Metro Inner Development Assessment Panel Agenda

Meeting Date and Time: Wednesday, 7 May 2025; 9:30am
Meeting Number: MIDAP/71
Meeting Venue: 140 William Street, Perth

3.1 Lot 414 (No.37) Clark Street, Nedlands - Five (5) Group Dwellings –
DAP/24/02785

3.2 Lot 381 (No.6) Alexander Road, Dalkeith - 5 Multiple Dwellings –
DAP/2820

City of Nedlands
 Amended Plans Received
 26 March 2025

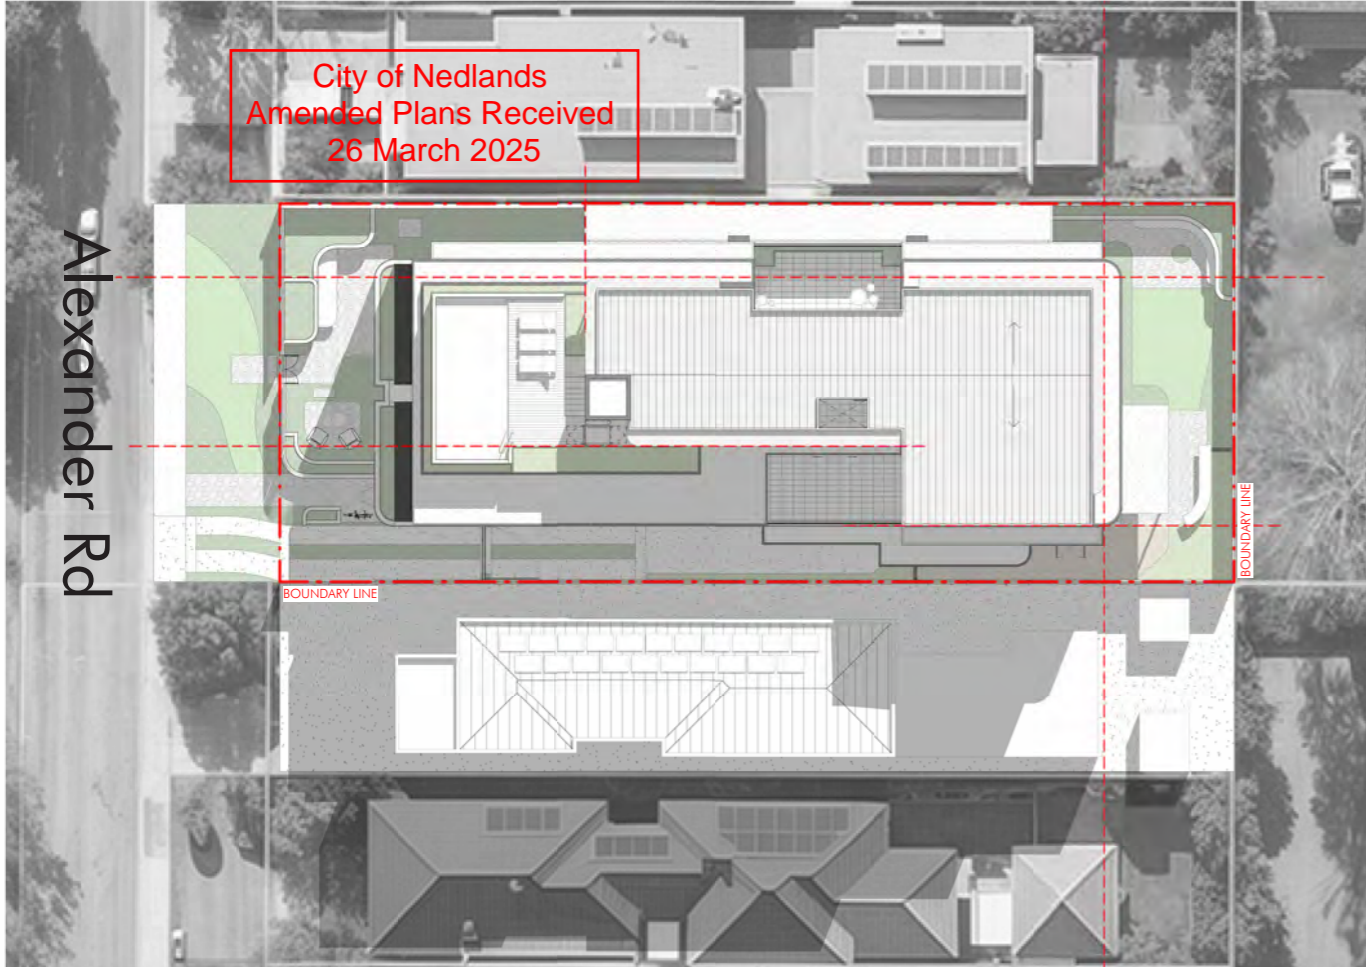
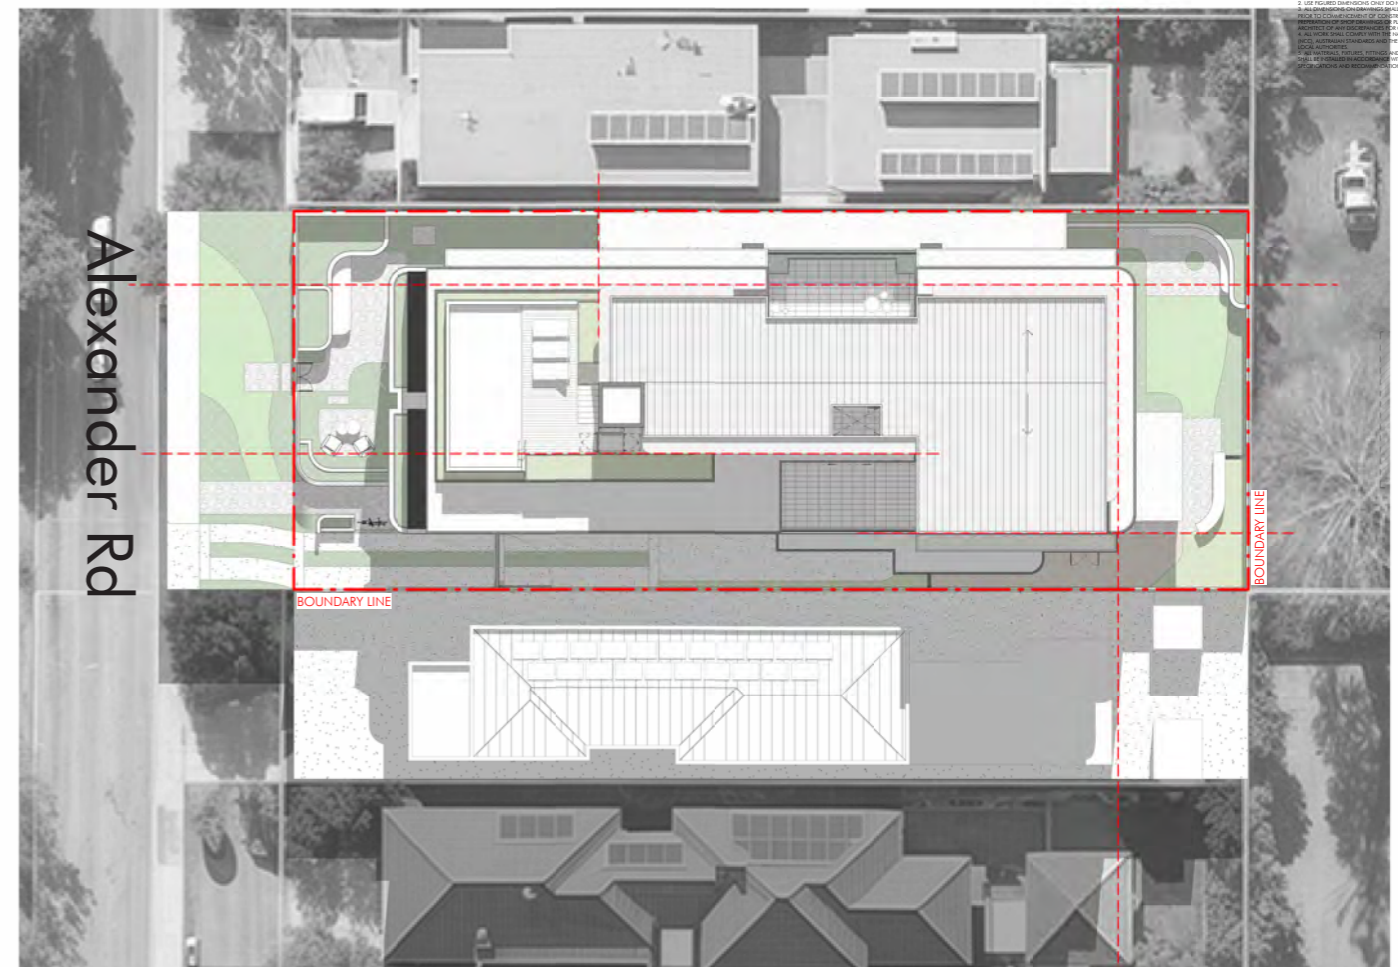
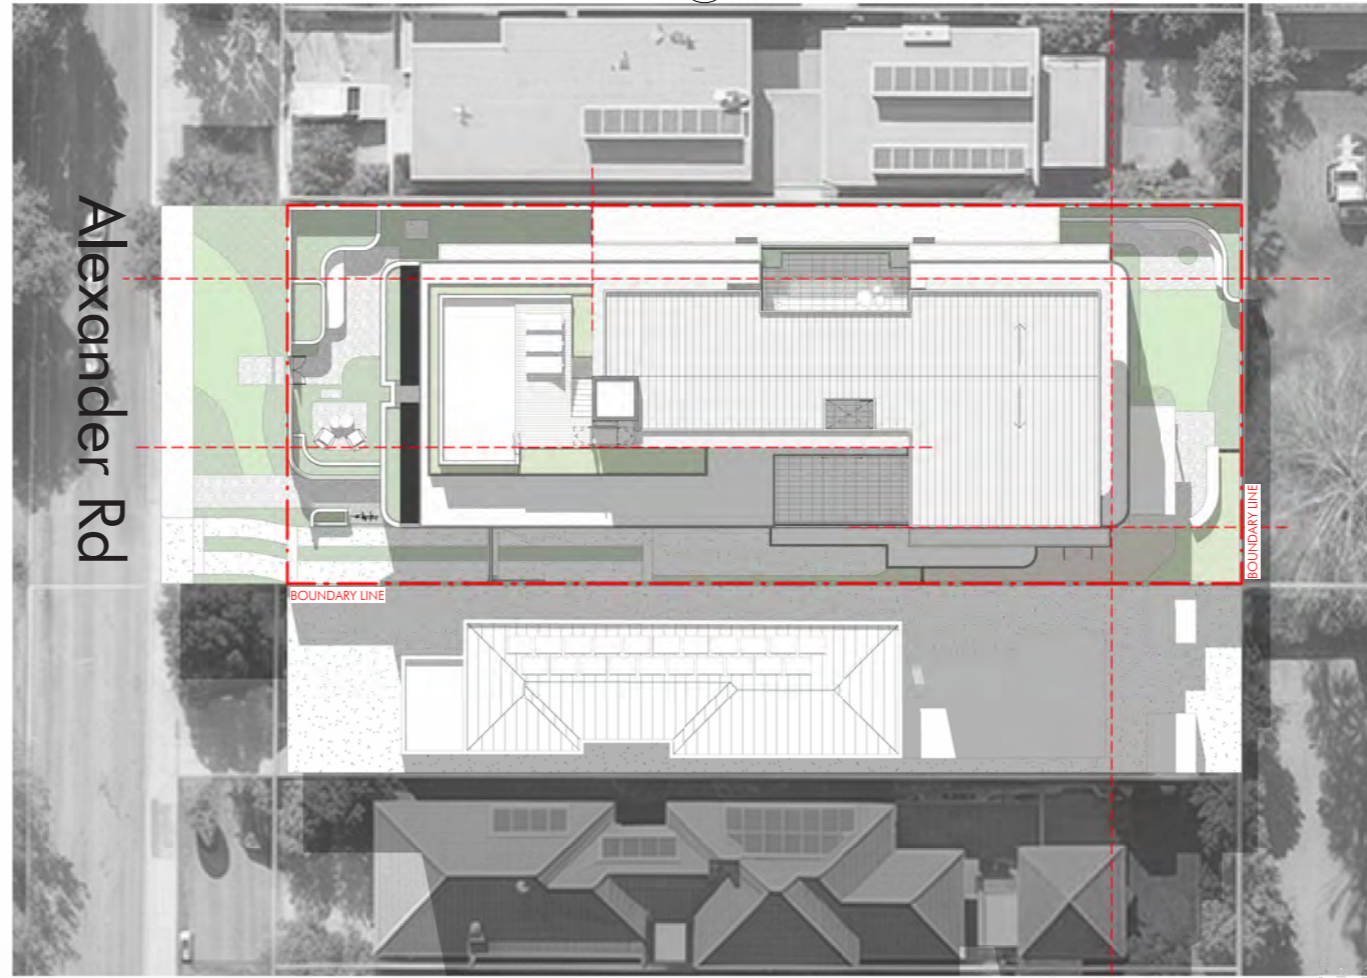
In relation to Element Objective O2.2.4, the proposed development does not appropriately recognise the need for solar access to the adjoining property at 8A Alexander Road. Based on development plans for 8A Alexander Road, the dwelling on that site features large north facing openings on both the ground and upper floors from internal living areas and outdoor living areas orientated north to gain winter sunlight.

It is acknowledged that the amended plans as received by the applicant dated 26 March 2025 aim at reducing the impact of the bulk on the streetscape and overshadowing by 'flipping' the massing of the fourth floor and relocating the building bulk to the east (rear). This allows the development to present as more of a three-storey building when viewed from the street. However, the proposal is still not considered to achieve the Element Objectives of O2.2.1 and O2.2.4.

Figure 4: Sight Distance Check

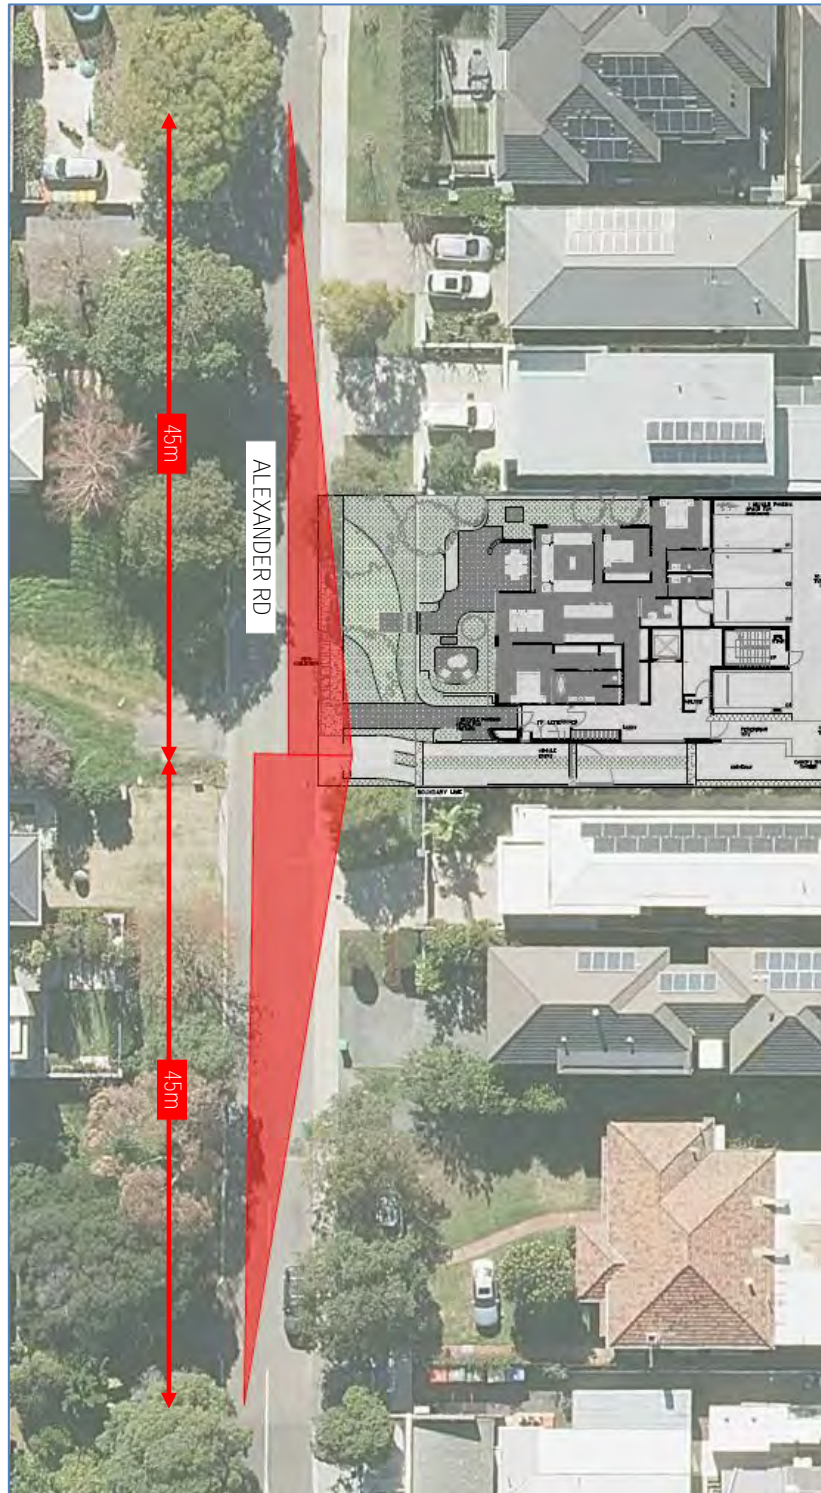
9. The revised traffic review Figure 4, does not take into account the large number of cars regularly parked along the eastern side of Alexander Rd due to the shopping precinct just 60m away from the driveway. A large number of traffic movements from the site, with visibility obstructed by parked cars, substantially increases the risk of vehicle collisions.
